CITY OF WEST LINN VALLEY VIEW DR AND SUNCREST DR STREET IMPROVEMENTS

PW-17-02

REVIEWED

By Morgan Palmer at 3:38 pm, Oct 24, 2018

DETAIL SHEET	
S3.4	
12 OF 40

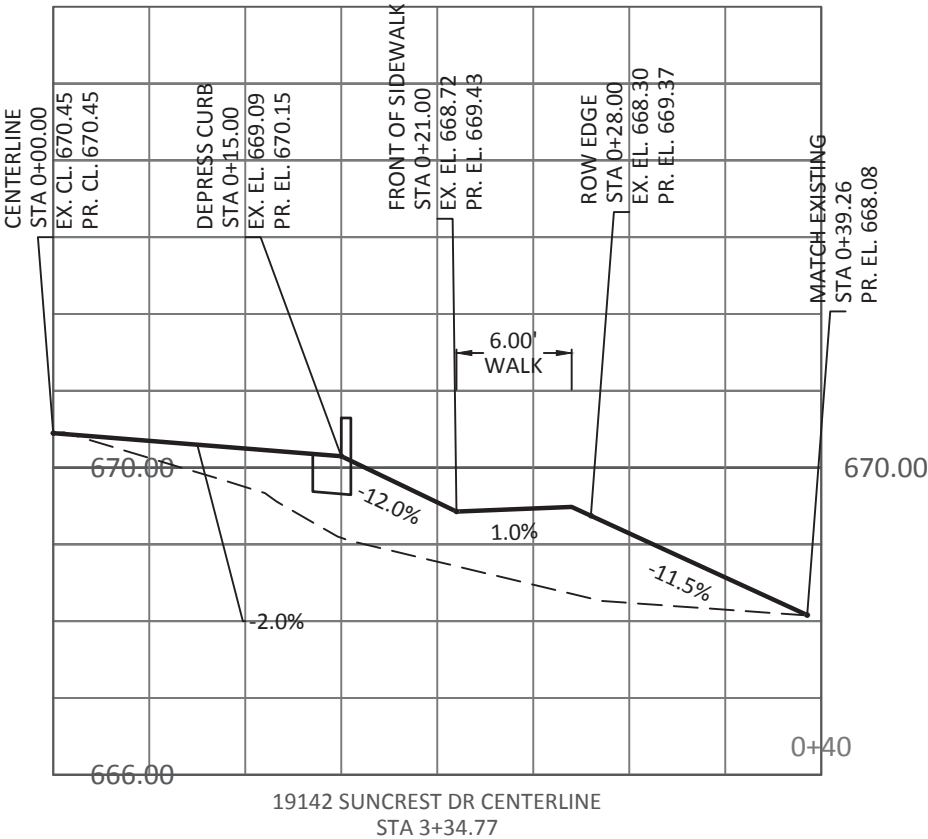
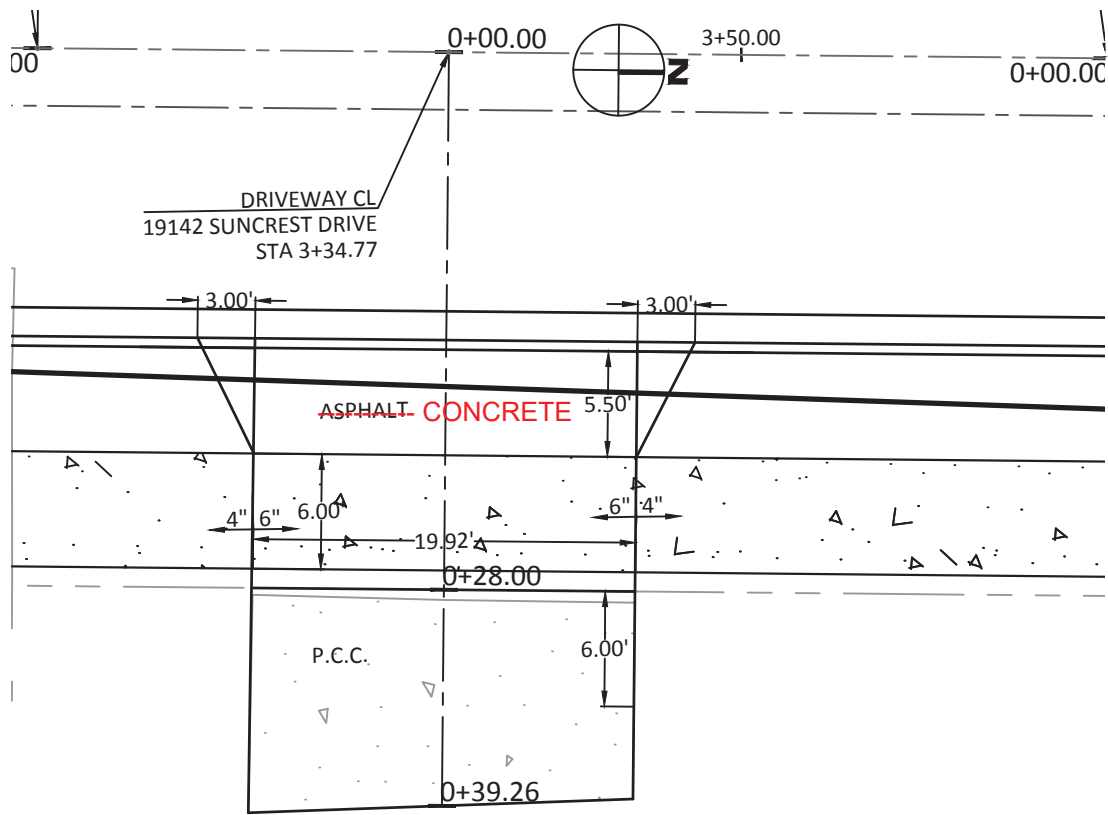
CONDUCT DRIVEWAY REPLACEMENT ACCORDING TO RIGHT-OF-ENTRY
AGREEMENT SIGNED ON 4/20/2018 (COMPLETED UNDER A SEPARATE CONTRACT)

S3.7

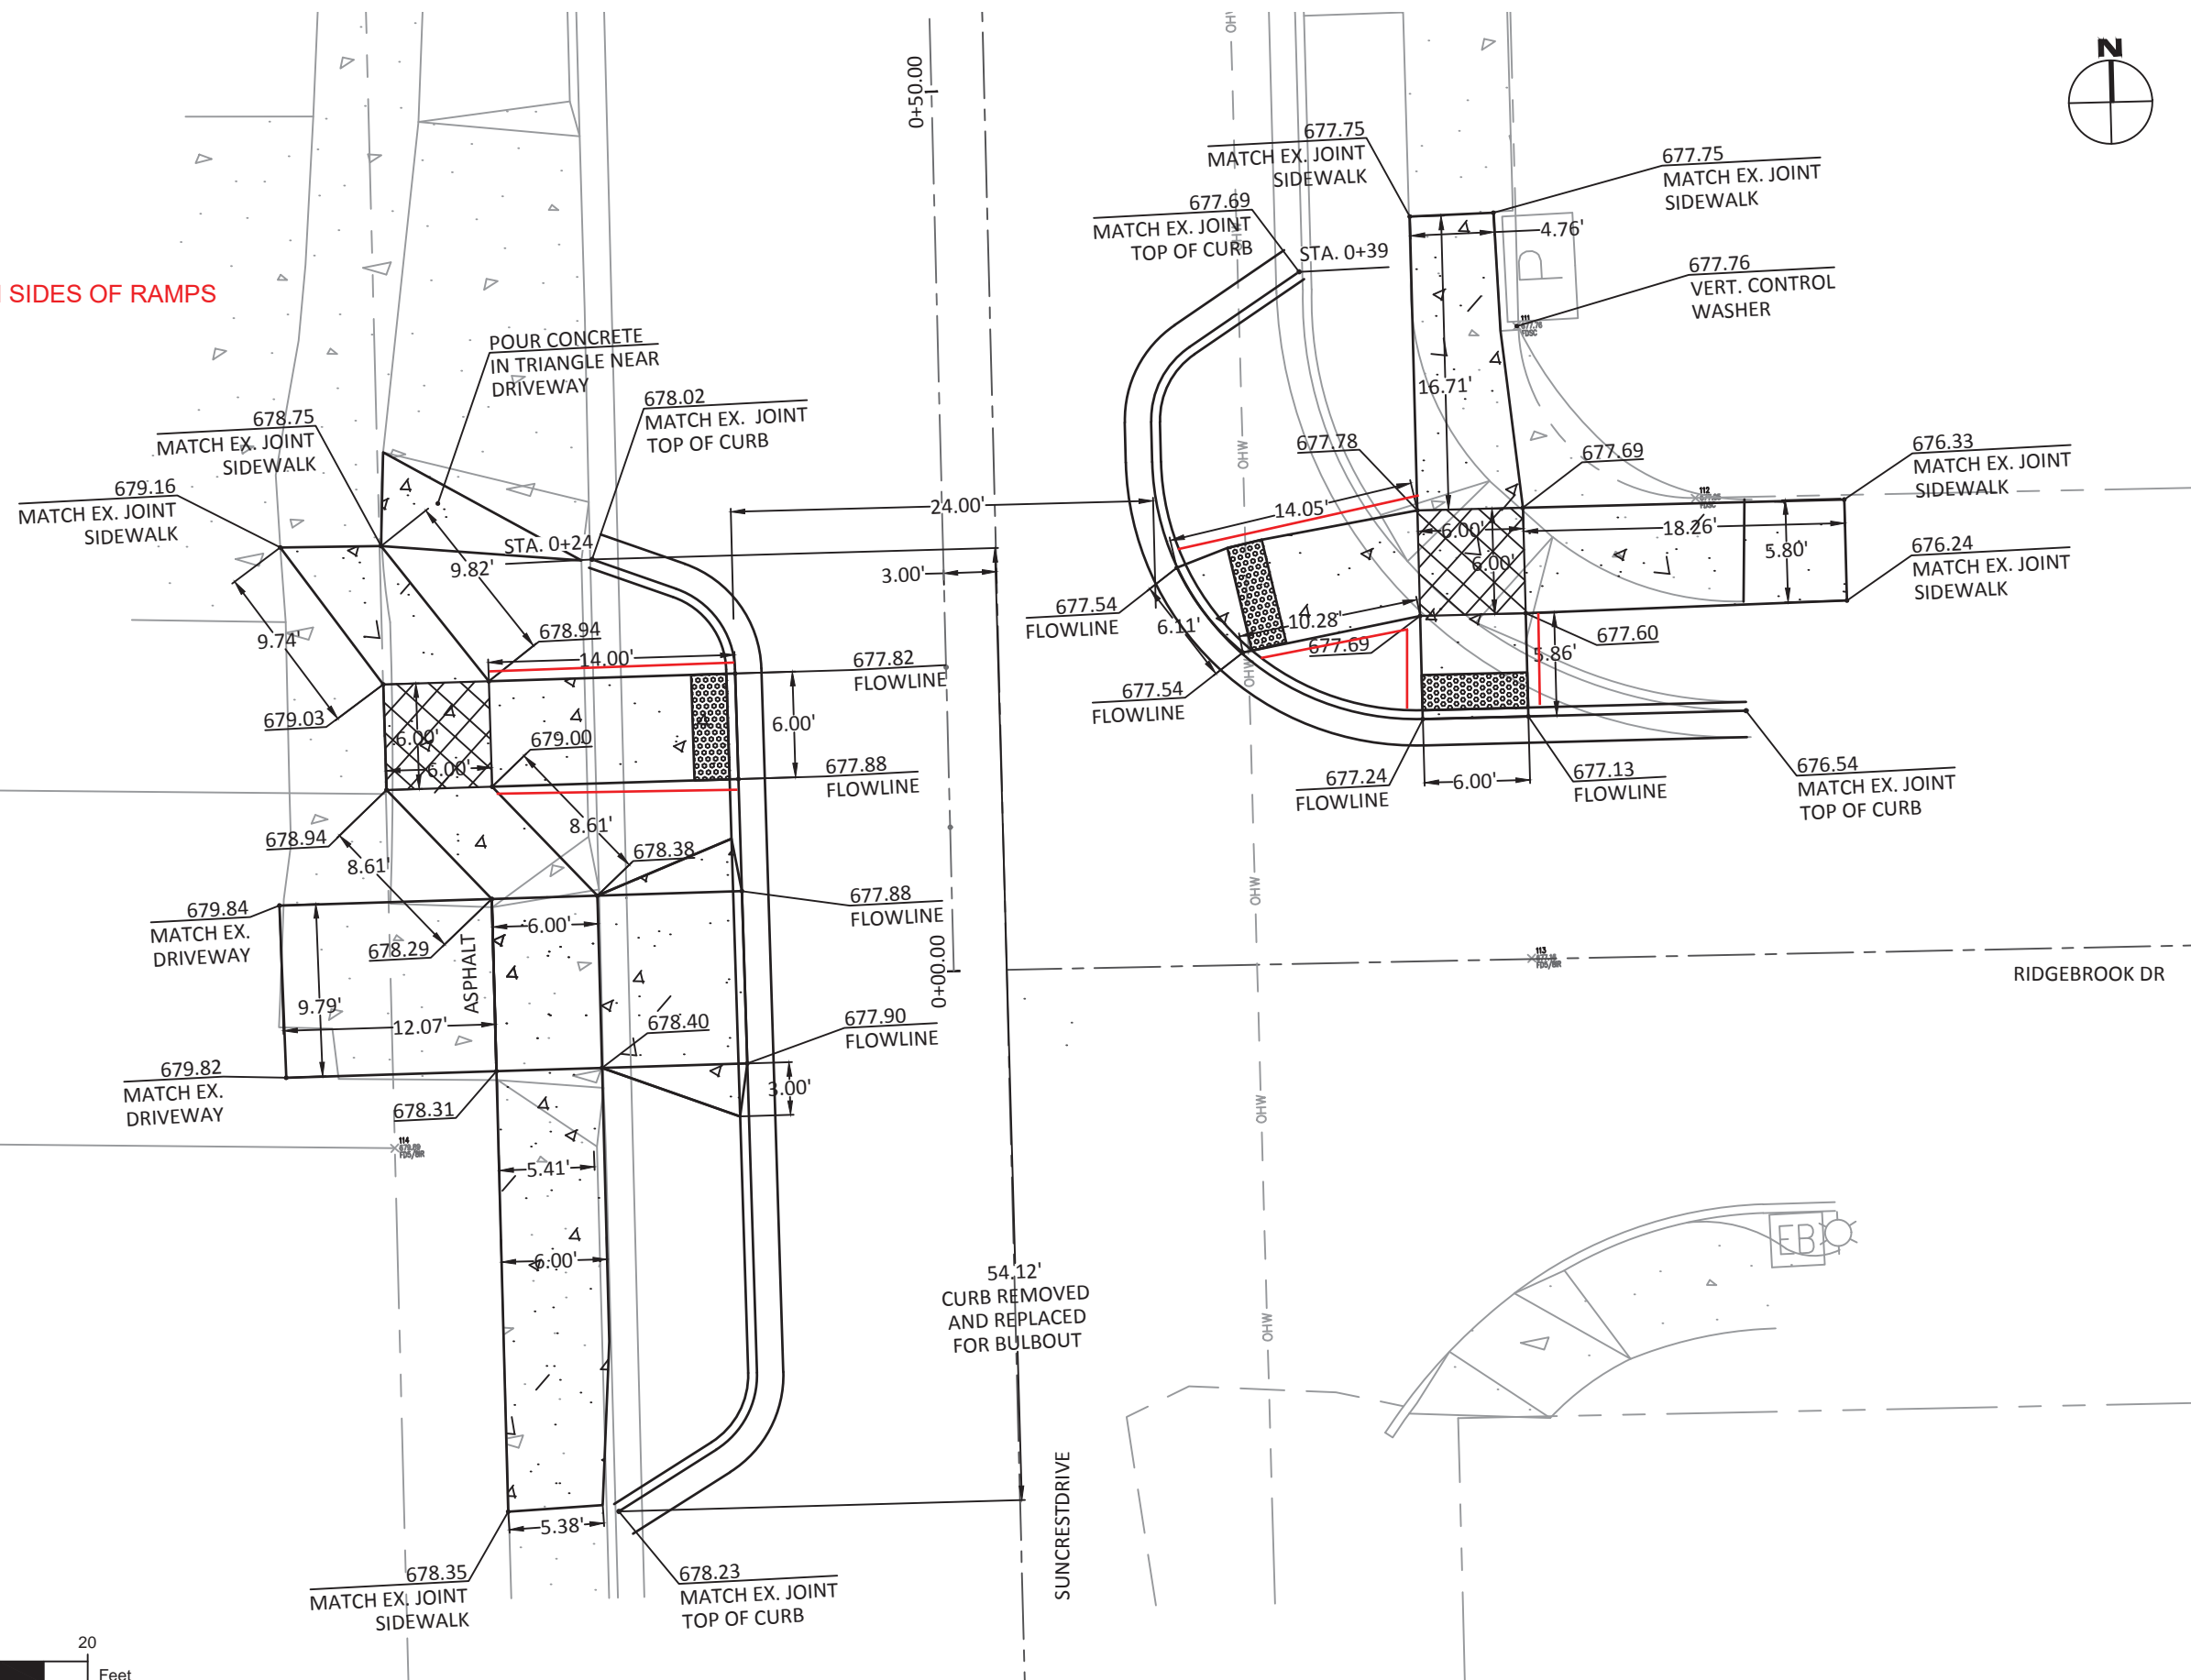
* CURBS ADDED ON SIDES OF RAMPS

S4.1

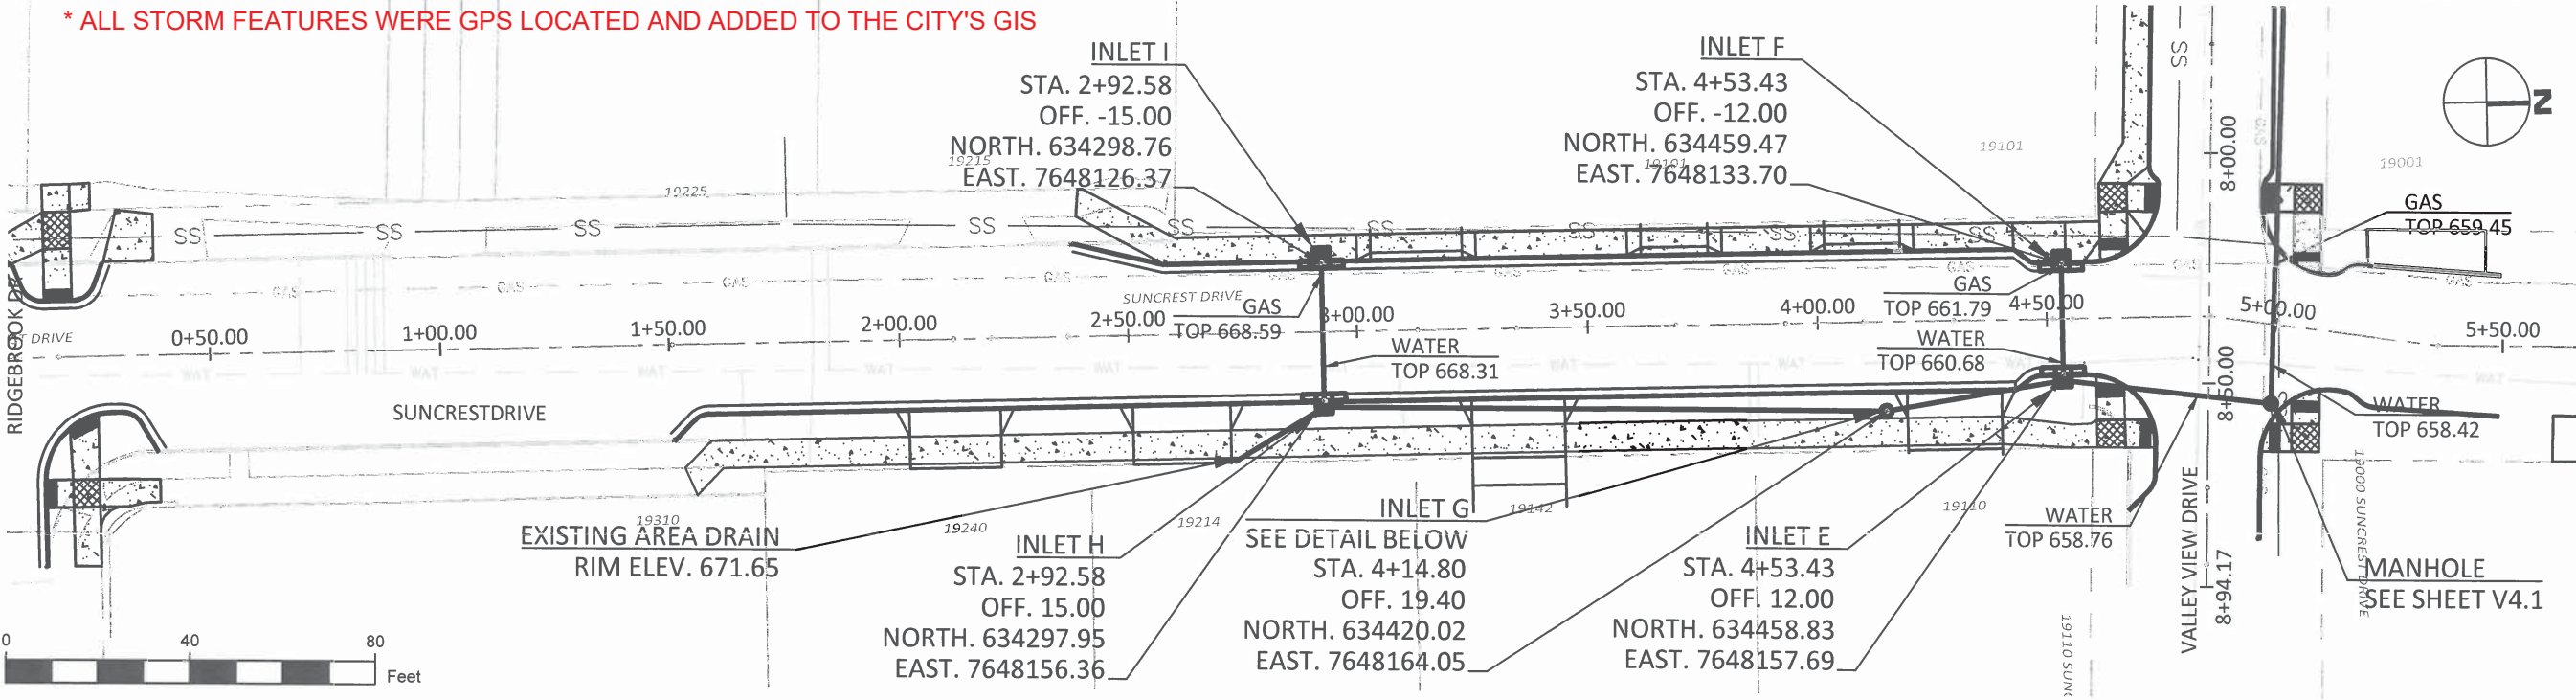
- INLET I - CURB INLET (WL-600)
STA 2+92.58
TOP OF CURB ELEV. ~~672.10~~ 672.15
INVERT ELEV. ~~669.80~~ (E) 669.84
- INLET H - CURB INLET (WL-600)
STA 2+92.58
TOP OF CURB ELEV. ~~672.10~~ 672.00
INVERT ELEV. ~~668.81~~ (W) 668.79
INVERT ELEV. ~~668.81~~ (SE) CONNECT 4" PVC TO EXISTING AREA DRAIN 668.95
INVERT ELEV. ~~668.36~~ (N) 666.35
- INLET G - BEEHIVE INLET
STA 4+14.80
TOP ELEV. ~~664.90~~ 665.90
RIM ELEV. 665.18
INVERT ELEV. ~~661.10~~ (S) 662.55
INVERT ELEV. ~~660.90~~ (N) 662.50
- INLET F - CURB INLET (WL-600)
STA 4+53.43
TOP OF CURB ELEV. ~~665.29~~ 665.19
INVERT ELEV. ~~662.29~~ (E) 662.79
- INLET E - CURB INLET (WL-600)
STA 4+53.43
TOP OF CURB ELEV. ~~665.29~~ 665.03
INVERT ELEV. ~~661.18~~ (W) 661.31
INVERT ELEV. ~~660.12~~ (S) 660.93
INVERT ELEV. ~~659.92~~ (N) 660.72

DETAIL SHEET
V3.2
26 OF 40

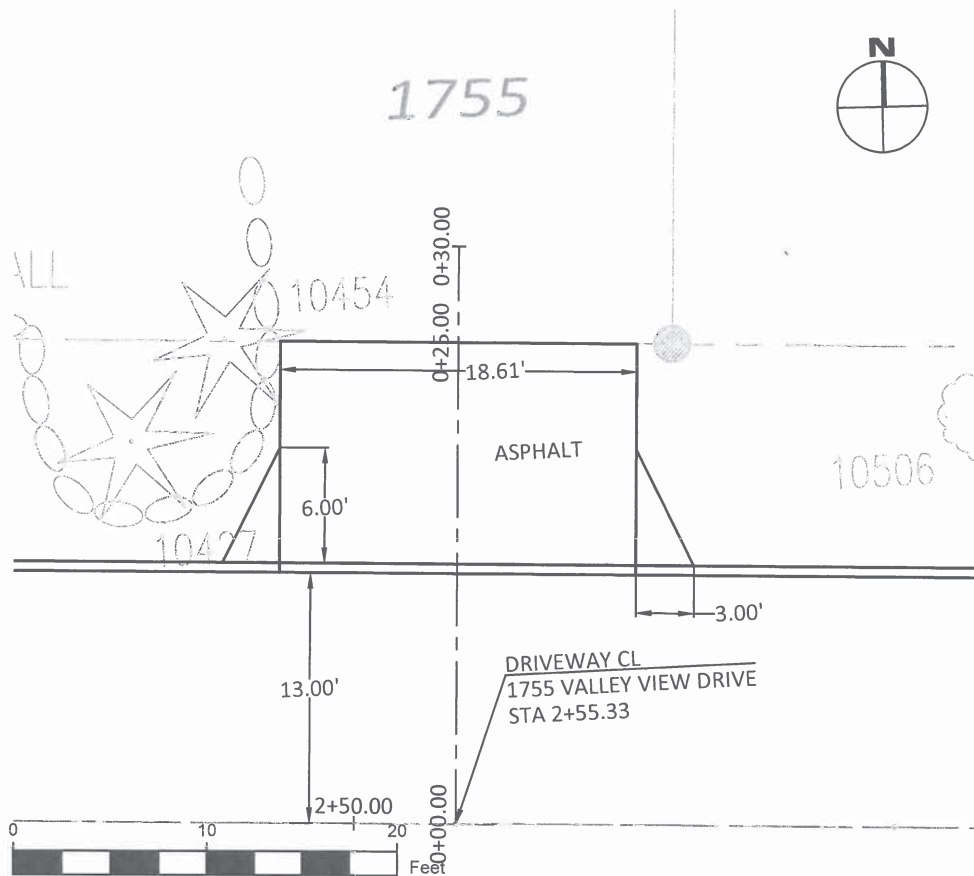
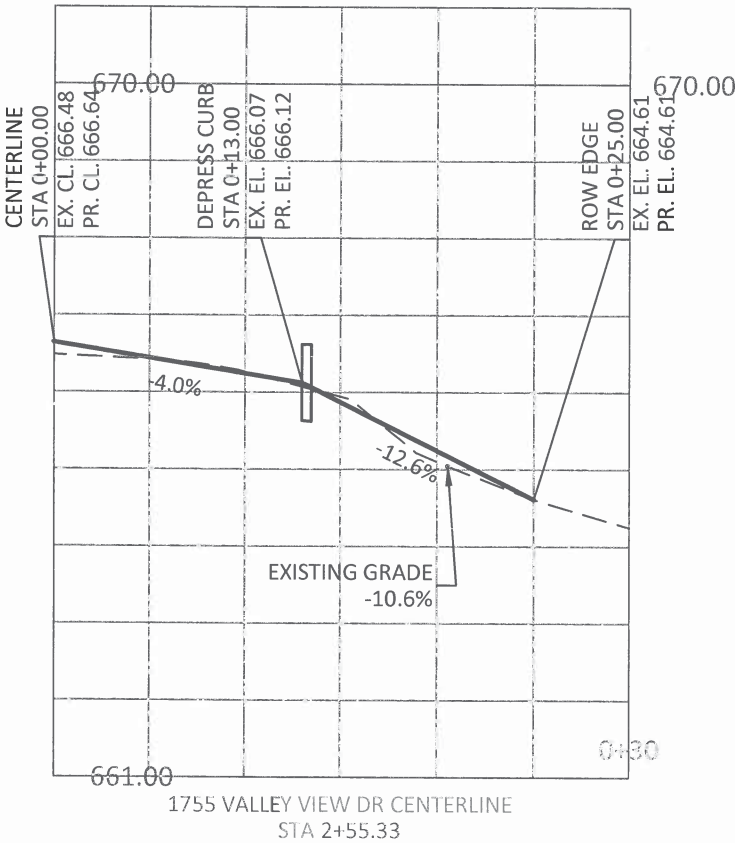
CONCRETE WALK WAS REPLACED ACCORDING TO RIGHT-OF-ENTRY
AGREEMENT SIGNED ON 05/09/2018

DETAIL SHEET	
V3.3	
27 OF 40

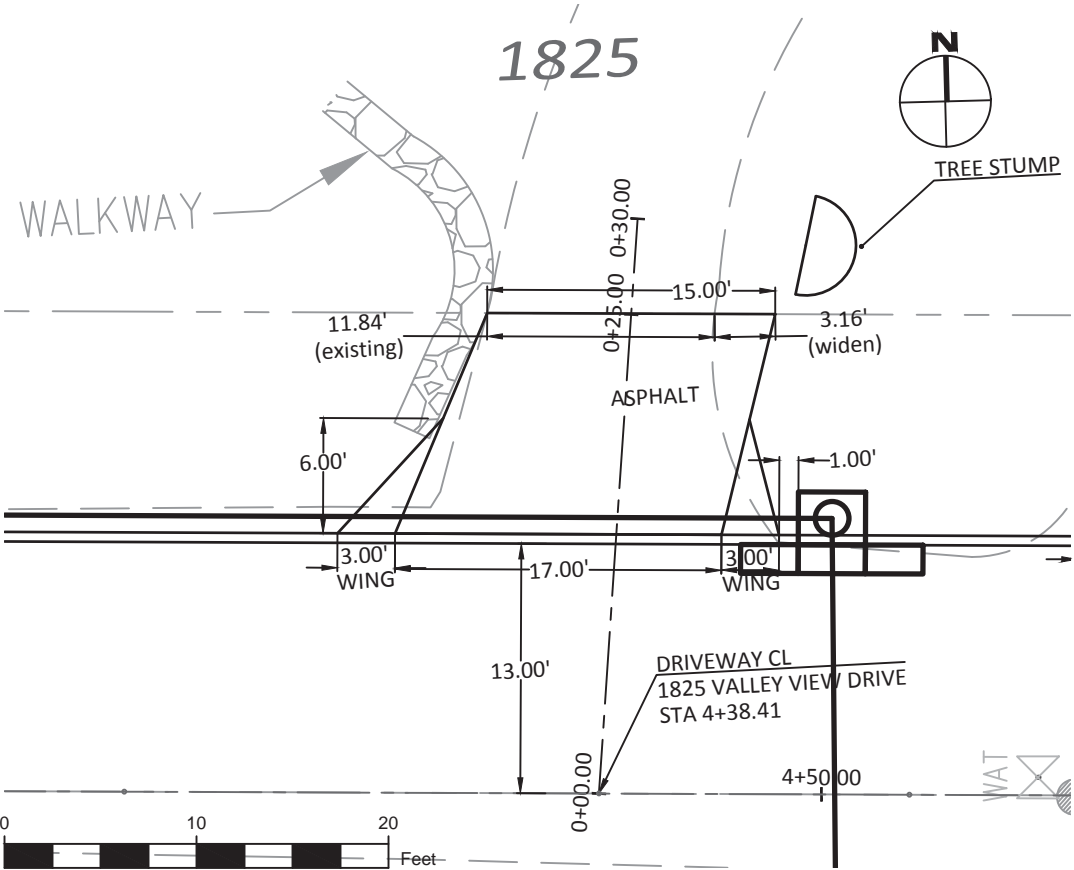
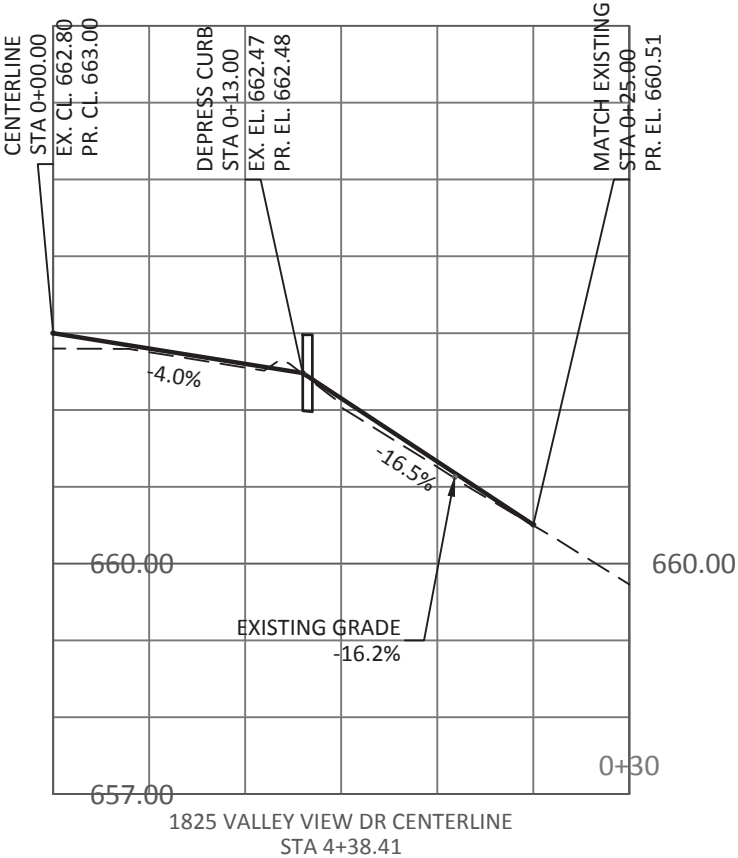
~~COORDINATE PAVING OF APPROACH WITH PRIVATE DRIVEWAY PAVING BY PROPERTY OWNER.~~
THE APPROACH WAS REPLACED ONLY.
